Addendum 1
Solicitation 21-99547
Brighton Beach Trail Relocation

This addendum serves to notify all bidders of the following changes to the solicitation documents:

REALIGNMENT PLAN FOR LAKEWALK EXTENSION:

FILE NO.
00616166
SHEET
9R

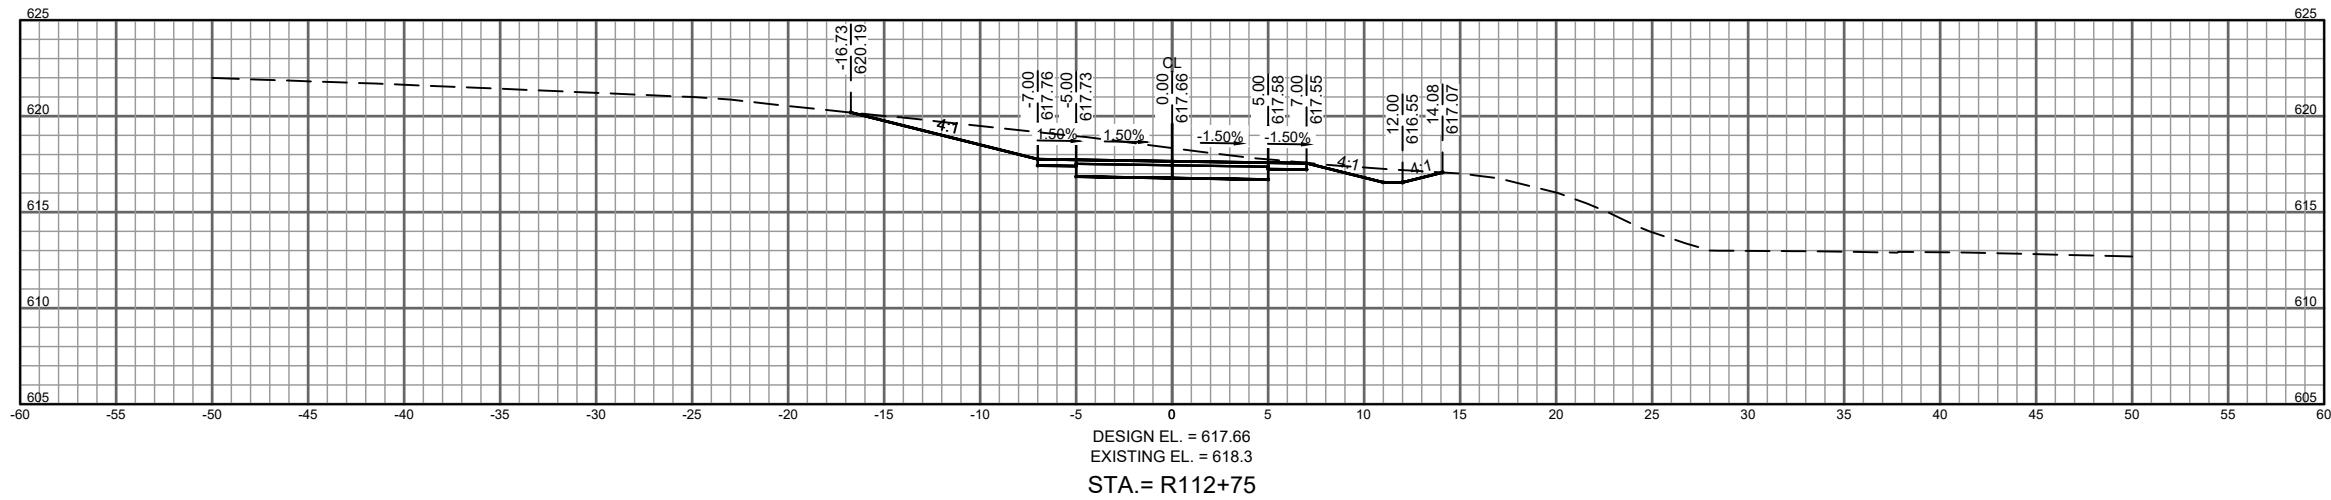
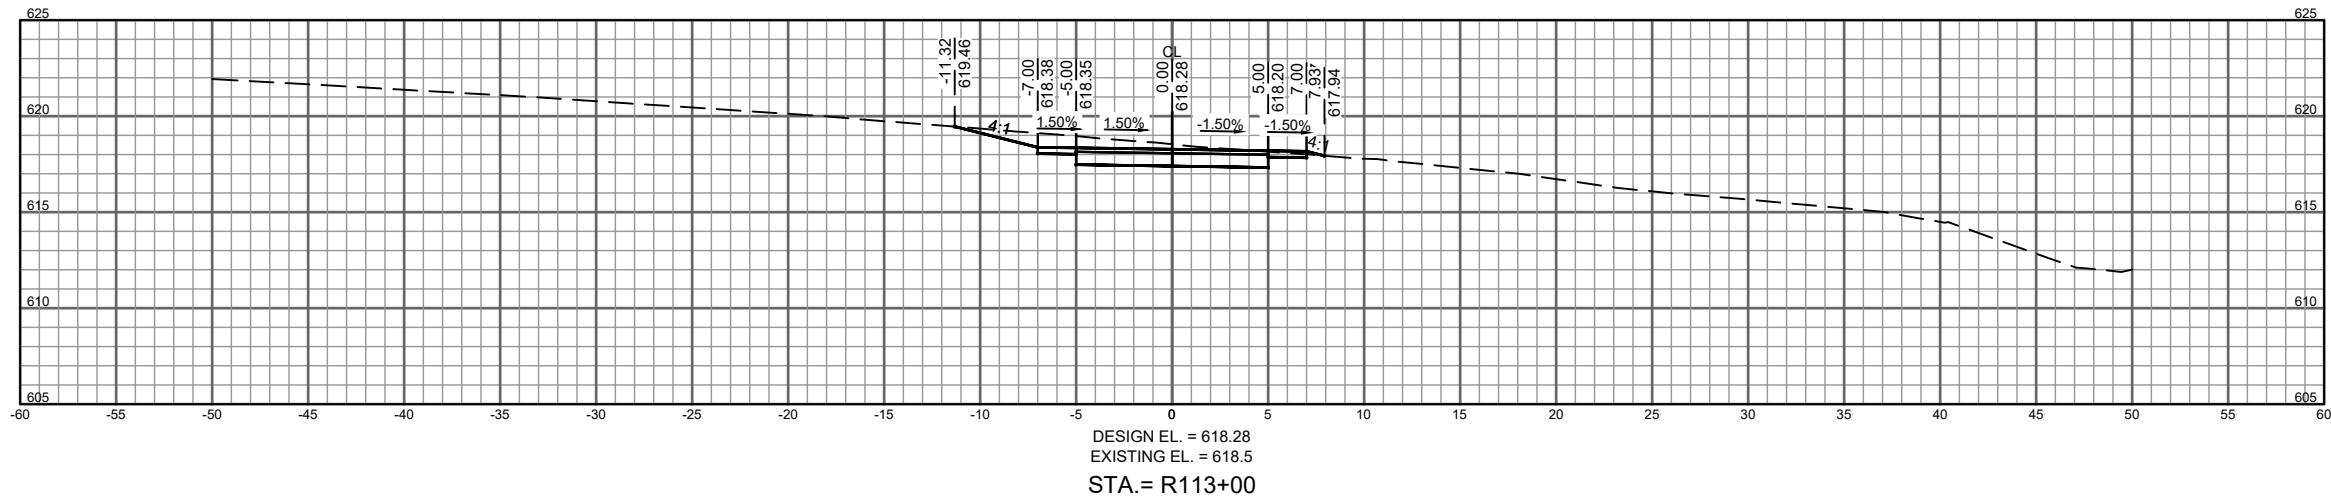
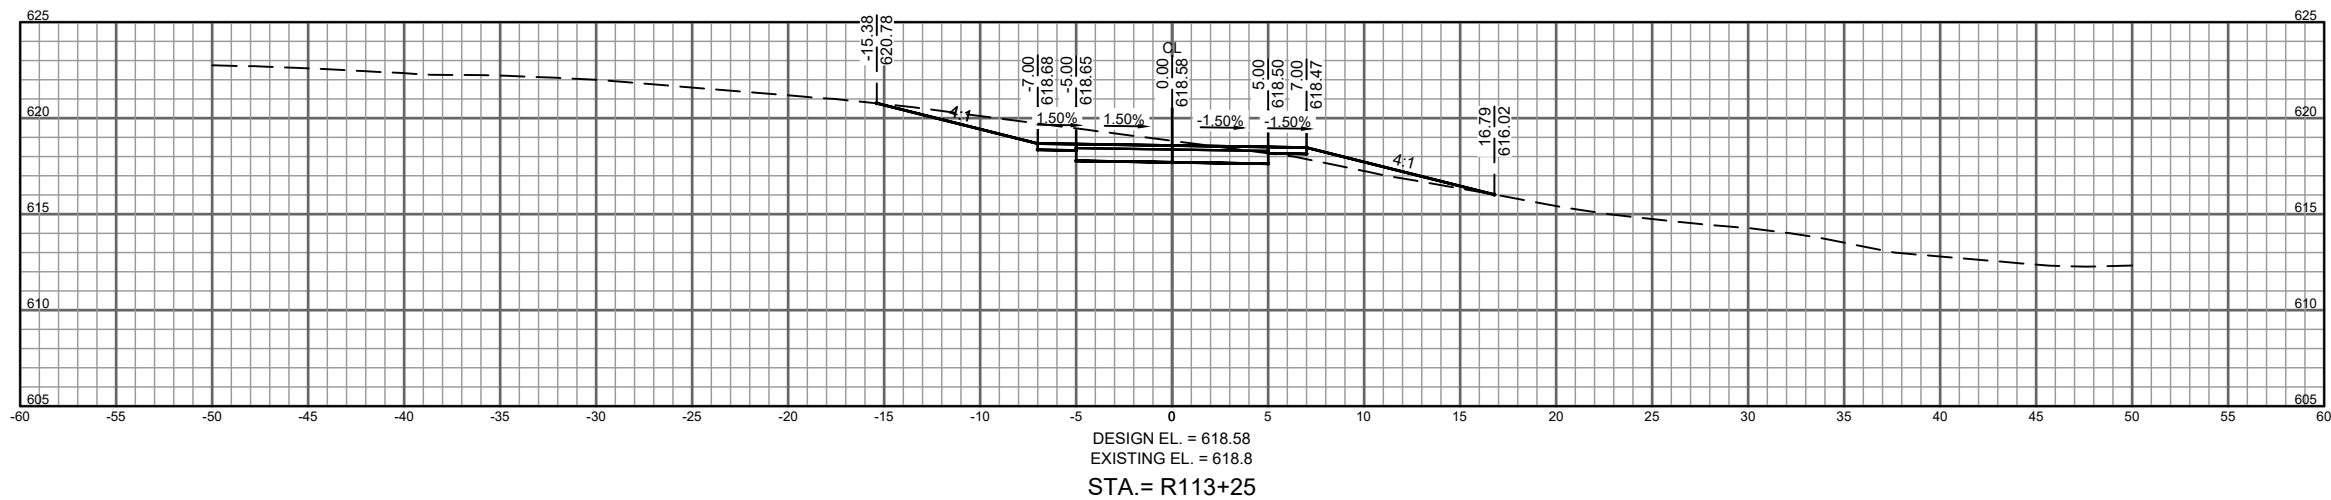
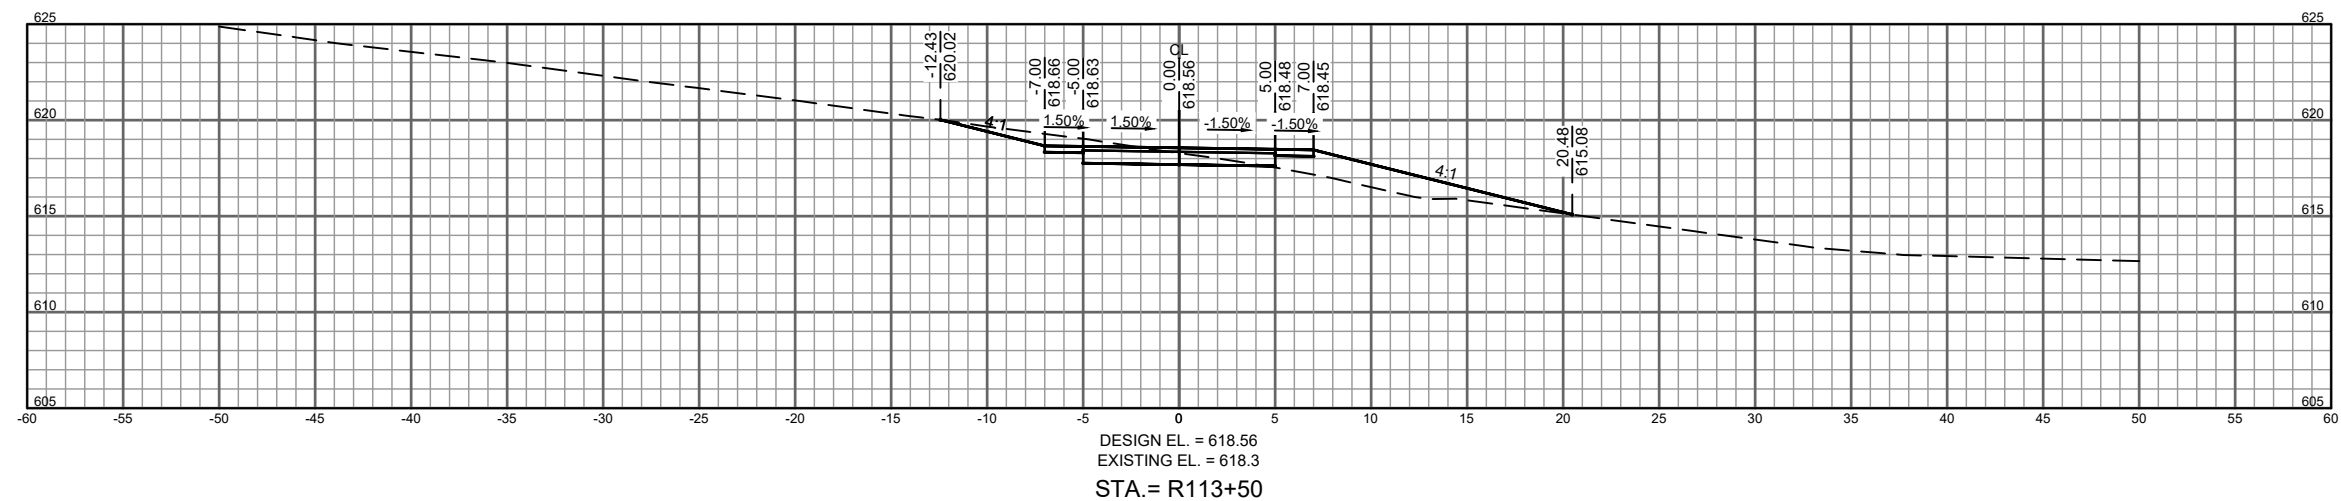
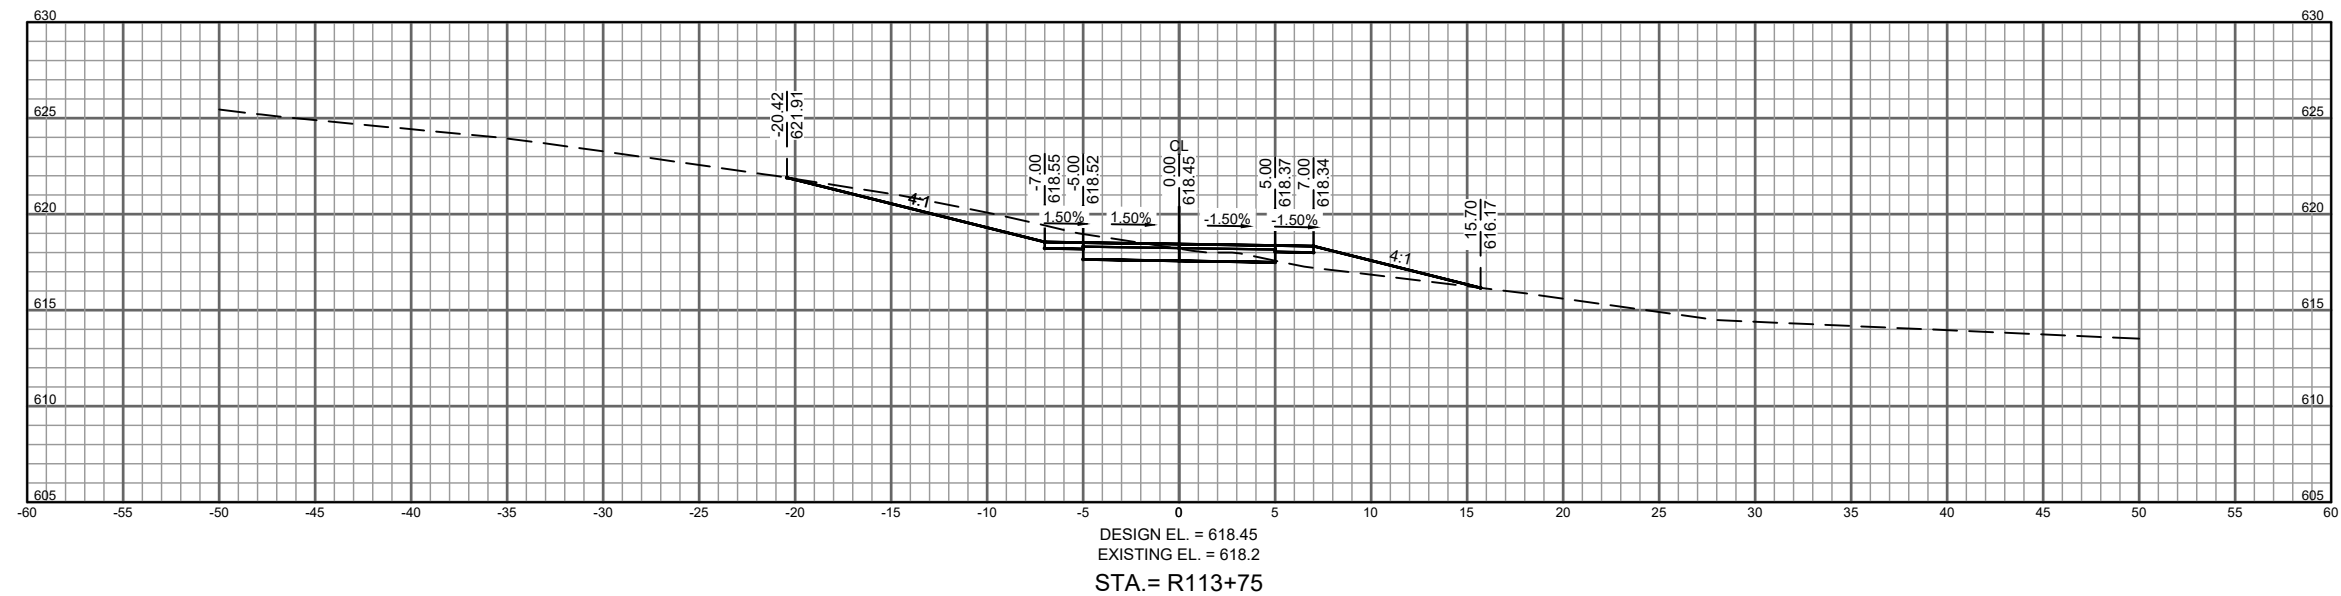
1. The pre-bid meeting sign-in sheet is attached.
2. A revised planset is attached. Changes to the plans are as follows:
 - a. Trail alignment and profile have been modified
 - b. Cross sections reflect the new alignment and profile
 - c. The CMP arch pipe is 21 in x 15 in
 - d. The Statement of Estimated Quantities chart has been updated
